Date 30 April 2007

Michelle Berryman  
Senior Environmental Coordinator  
KCGM  
Kalgoorlie  
WESTERN AUSTRALIA

## **RE INDEPENDENT REVIEW OF GOLDEN PIKE CUTBACK GEOTECHNICAL DESIGN**

Figure 3 Super Pit west wall south

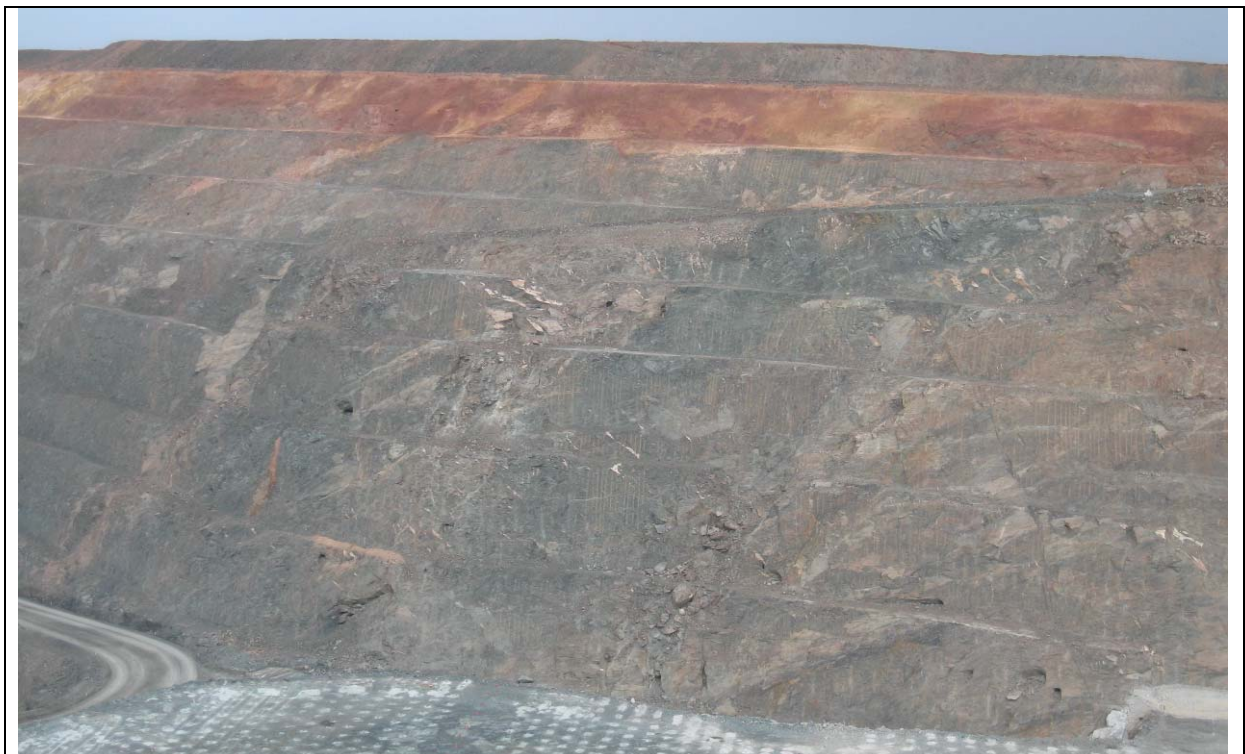
As is evident in Figure 2 and Figure 3 the performance of the current west wall slopes has been good. There are limited areas of instability noted and minimal rock fall debris (except for those associated with intersections with underground workings). Rock fall debris is increased below areas where the current slope intersects the underground workings (refer Figure 2 and Figure 3). Based on a visual assessment of the current slopes, these slopes are performing exceptionally well, well within acceptable batter scale instability tolerances. Additionally the blasting and batter cleanup practices and the general pit housekeeping standards are exceptionally high, allowing for potential to increase slope angles.
